ADDENDUM NO. 1

TO: PLANS AND SPECIFICATIONS FOR STATE OF MISSOURI

Remodel Space for Printshop Utilization
Scruggs Station Warehouse
Jefferson City, Missouri
PROJECT No.: O2544-01

A-101

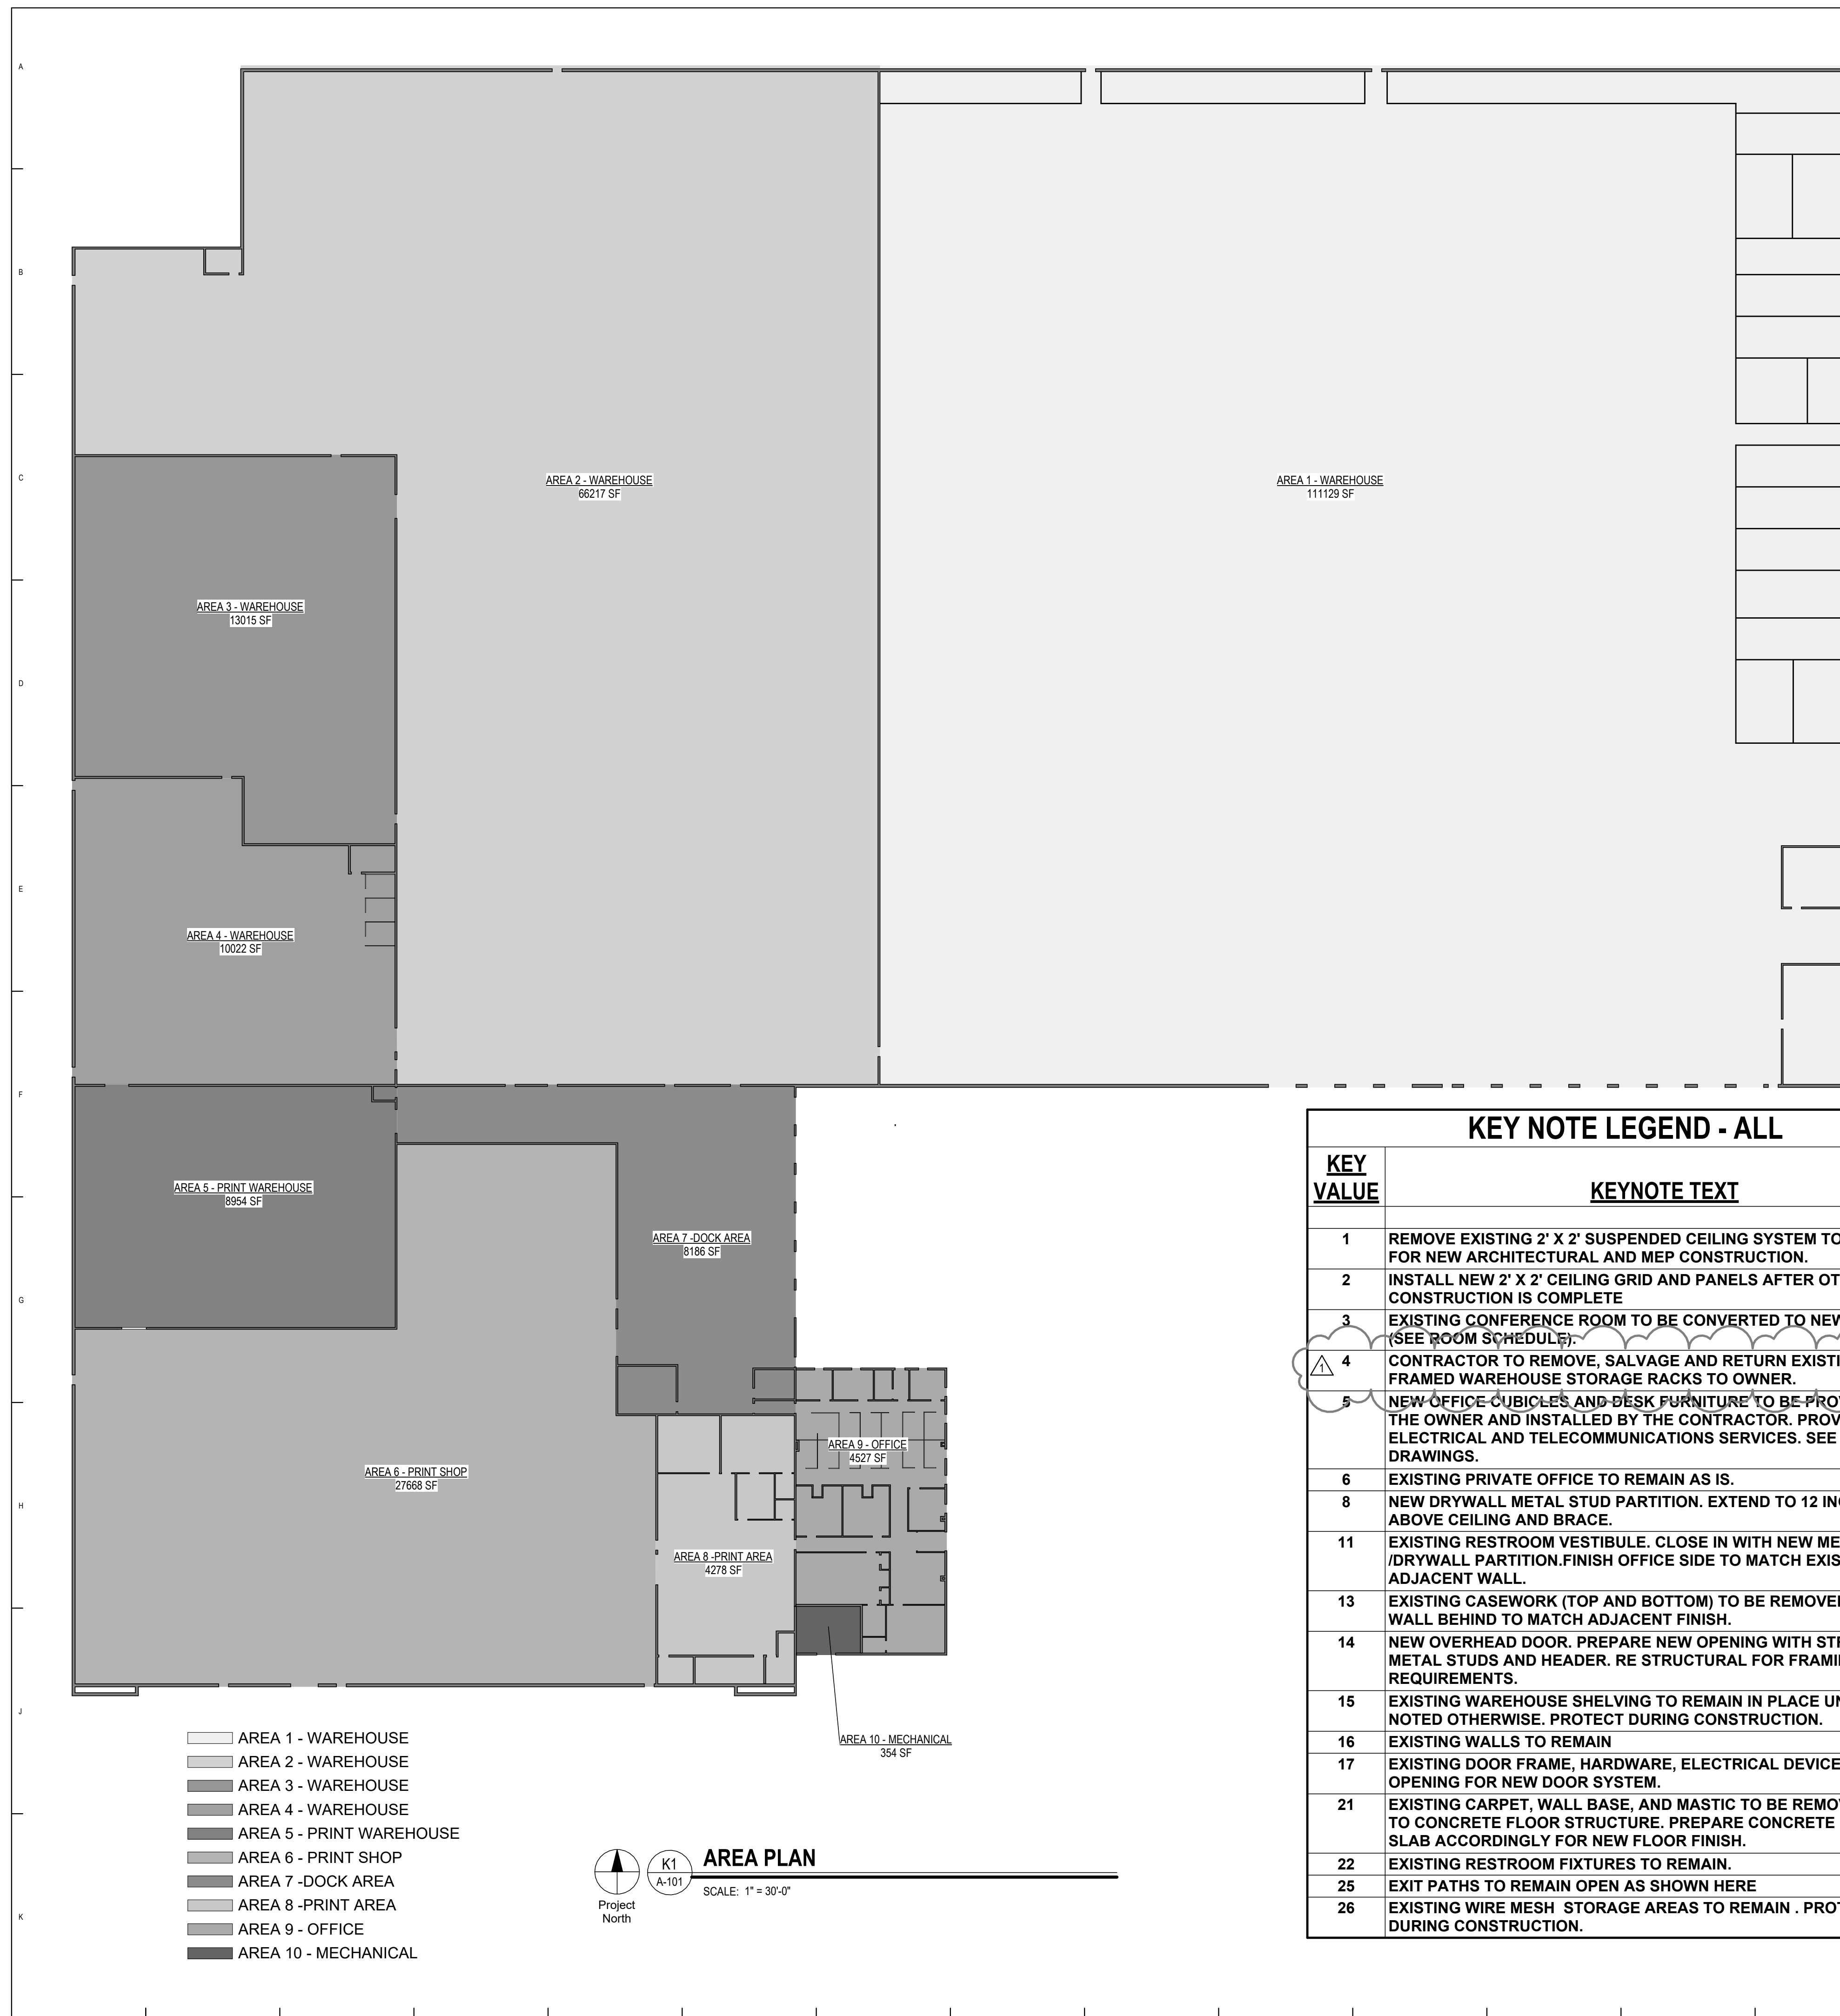
1. **Sheet A-101:** (full sheet re-issued)
 - a. Revised Keynote No. 4 : "Contractor to remove, salvage, and return existing steel framed warehouse storage racks to owner."

A-301

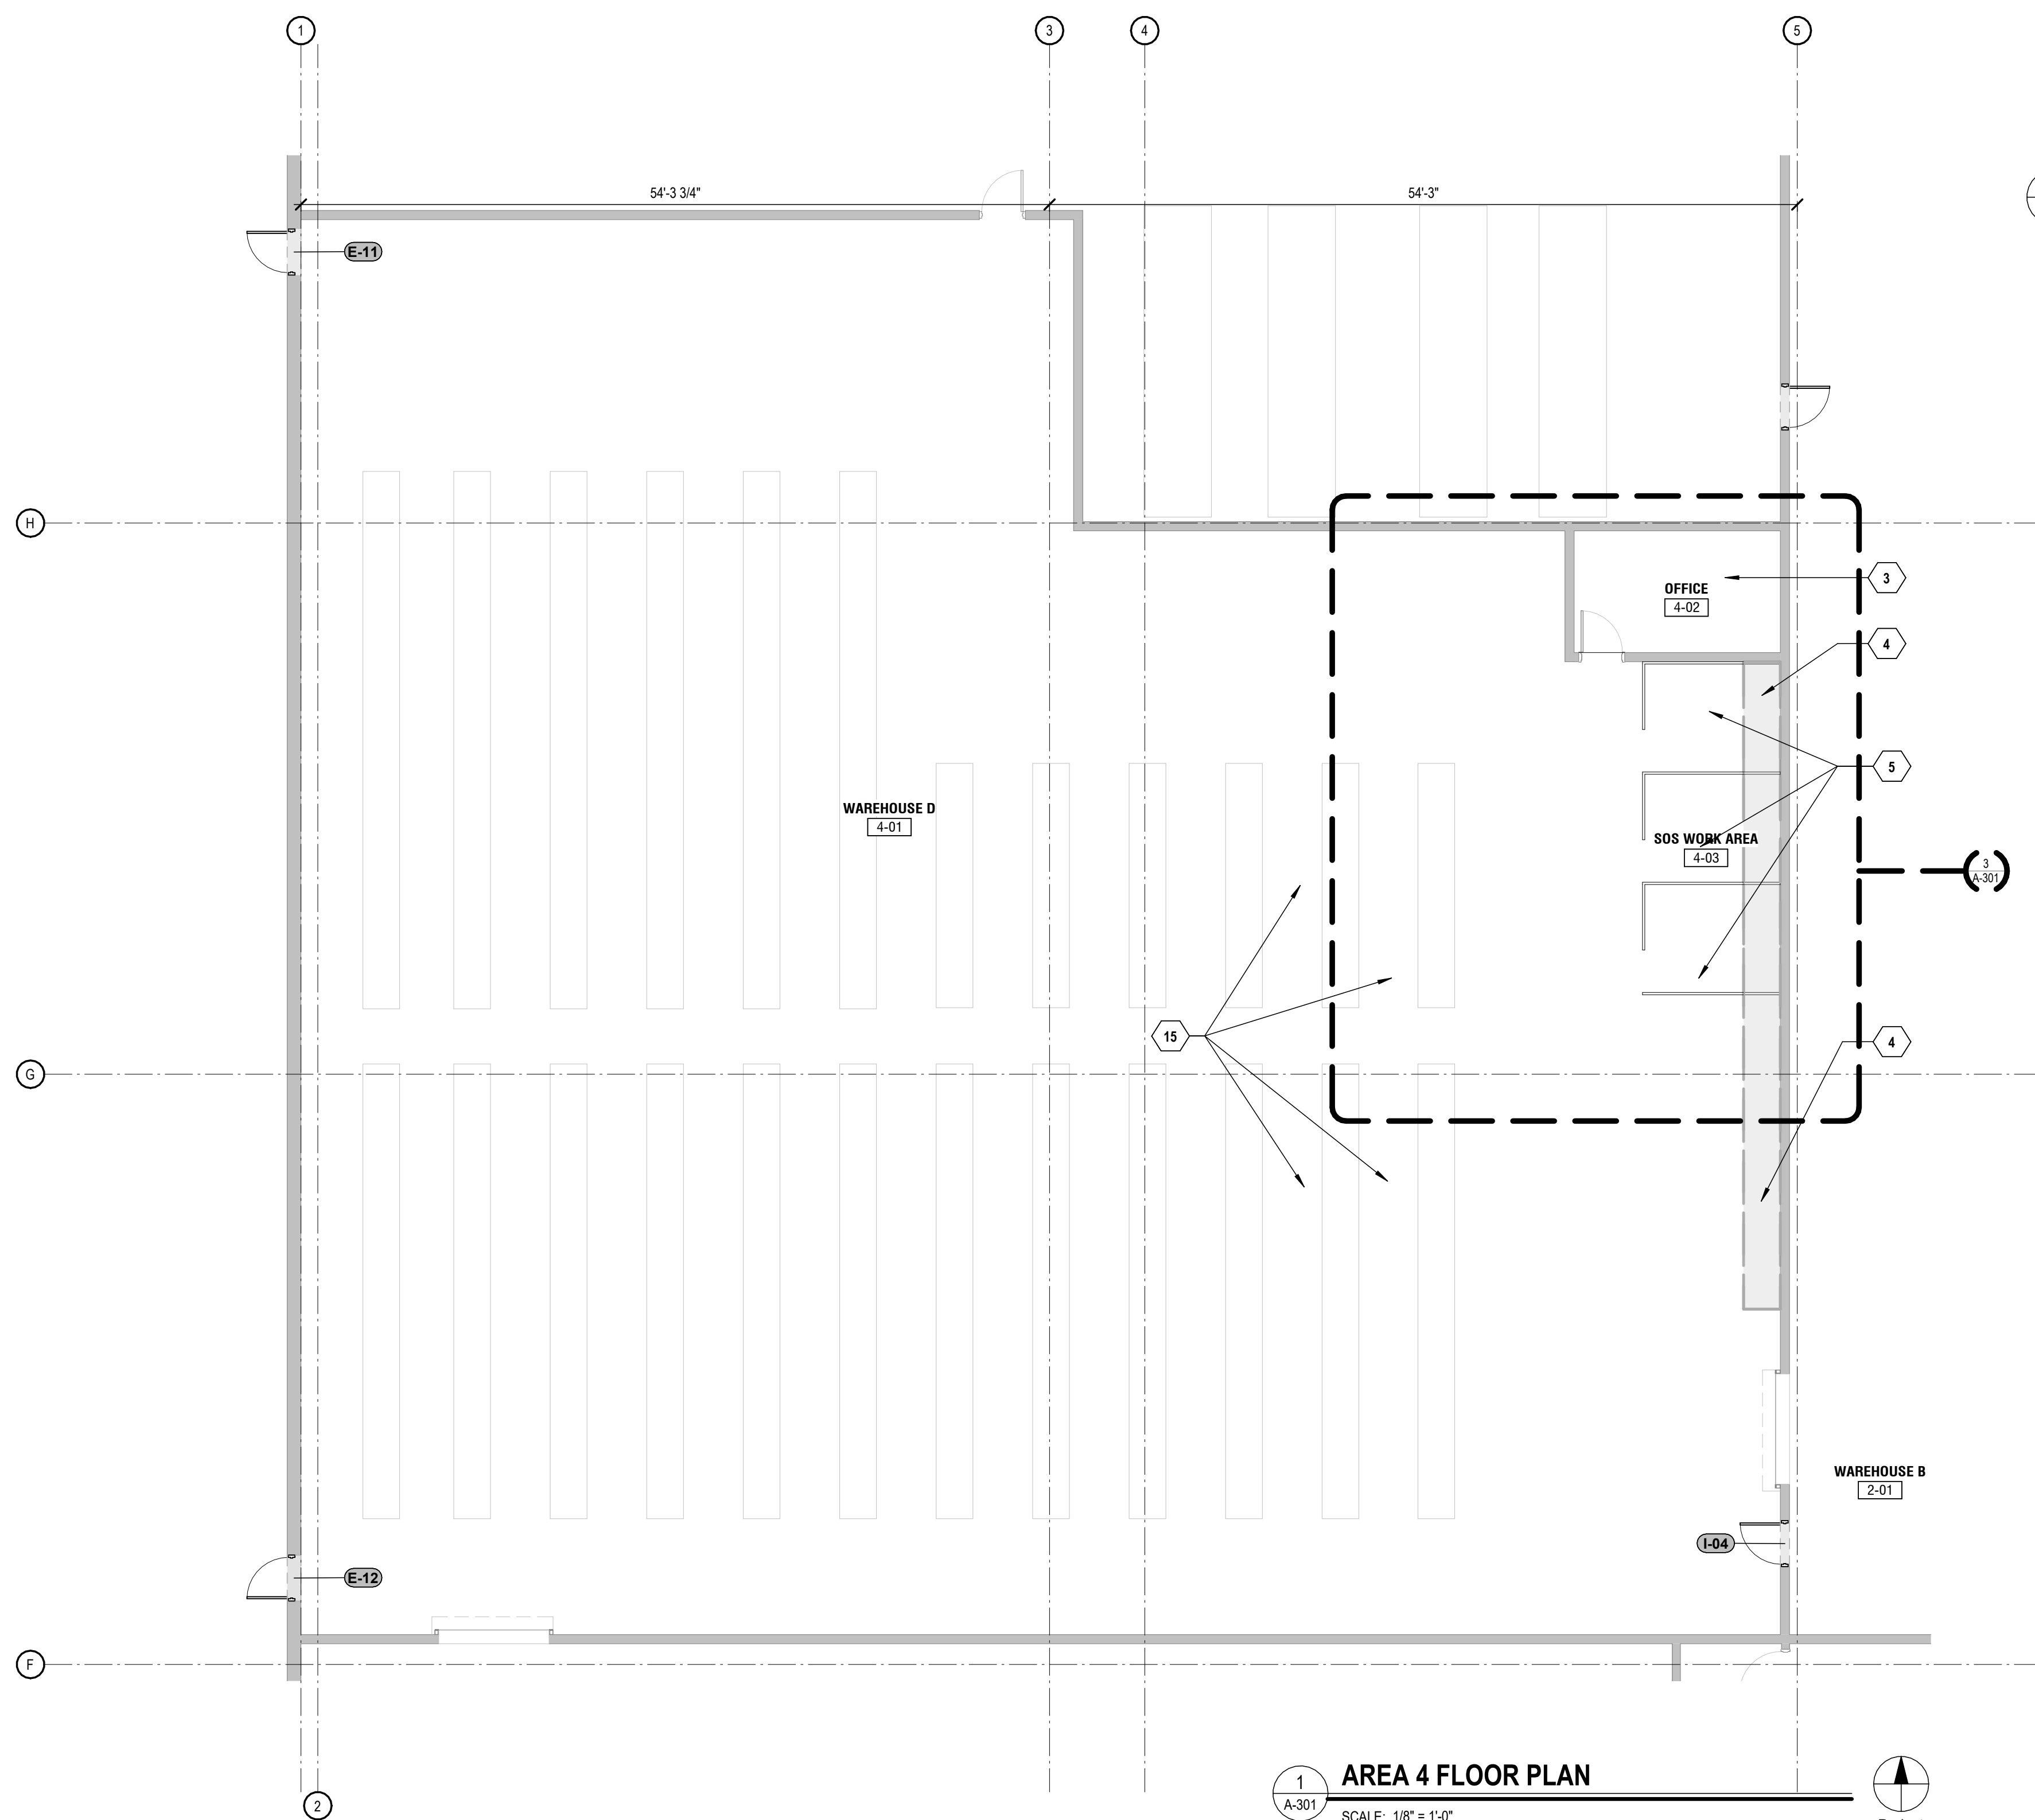
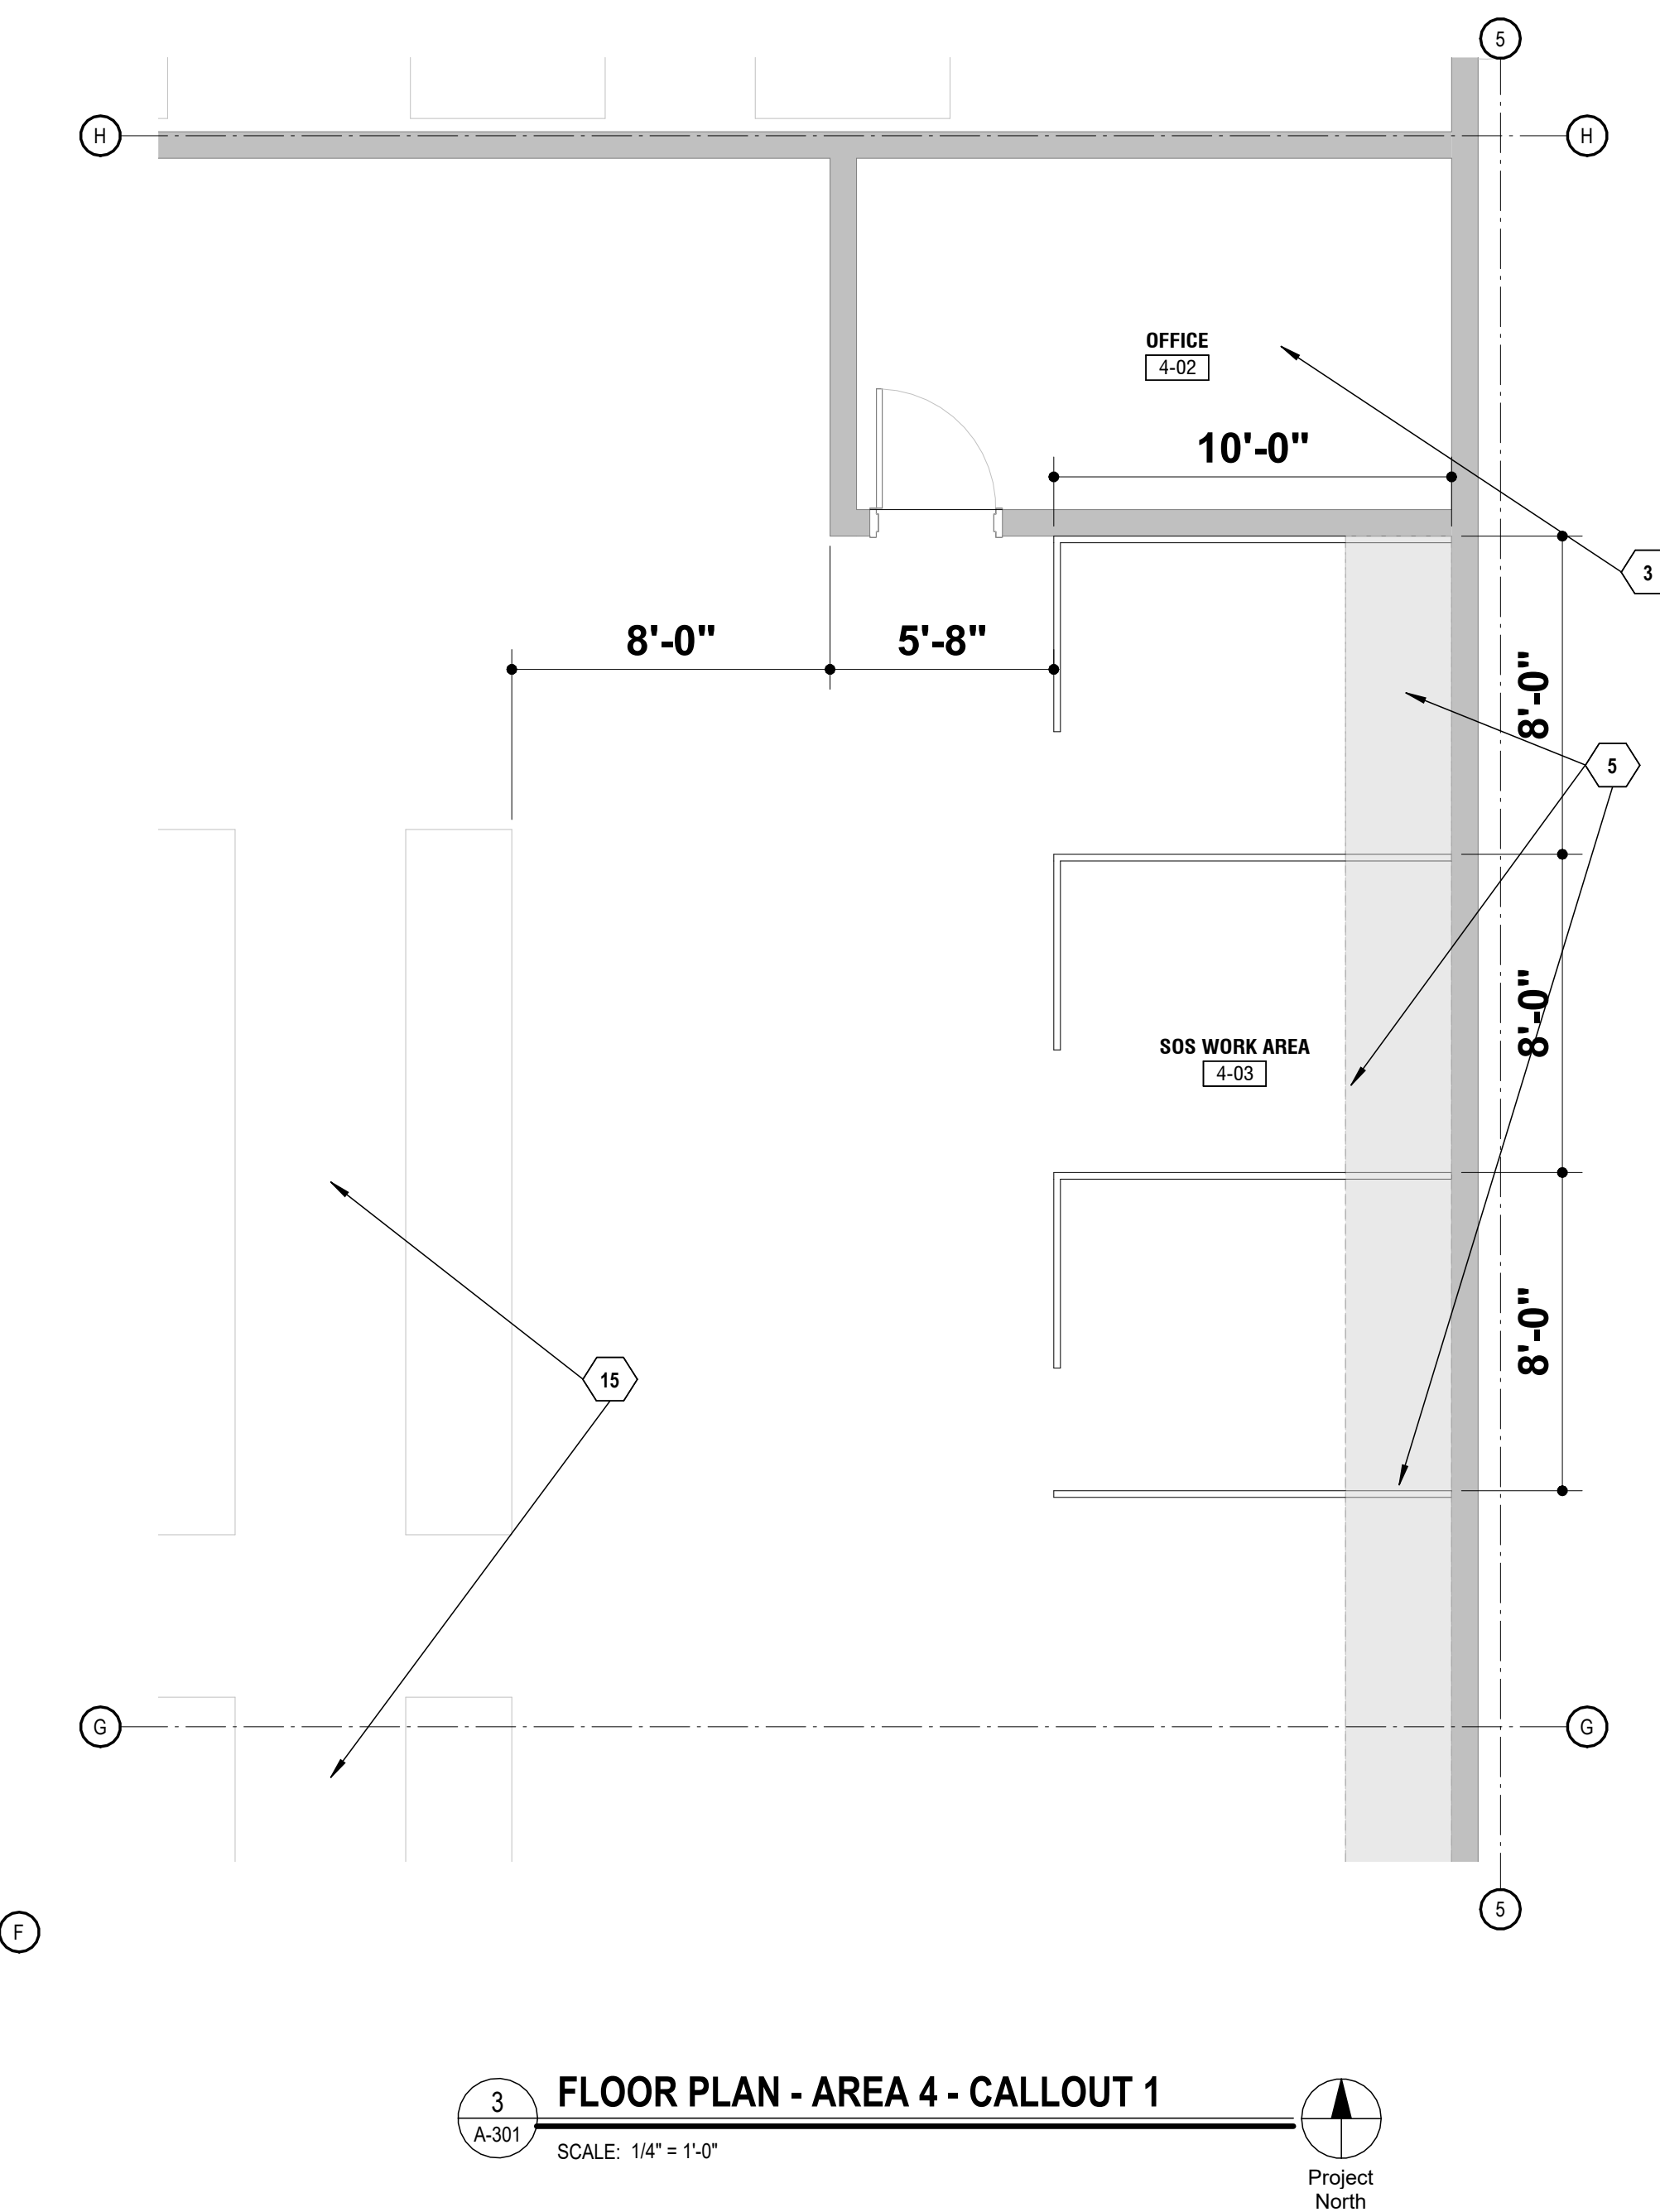
2. **Sheet A-301:** (full sheet re-issued)
 - a. Revised Keynote No. 4 : "Contractor to remove, salvage, and return existing steel framed warehouse storage racks to owner."
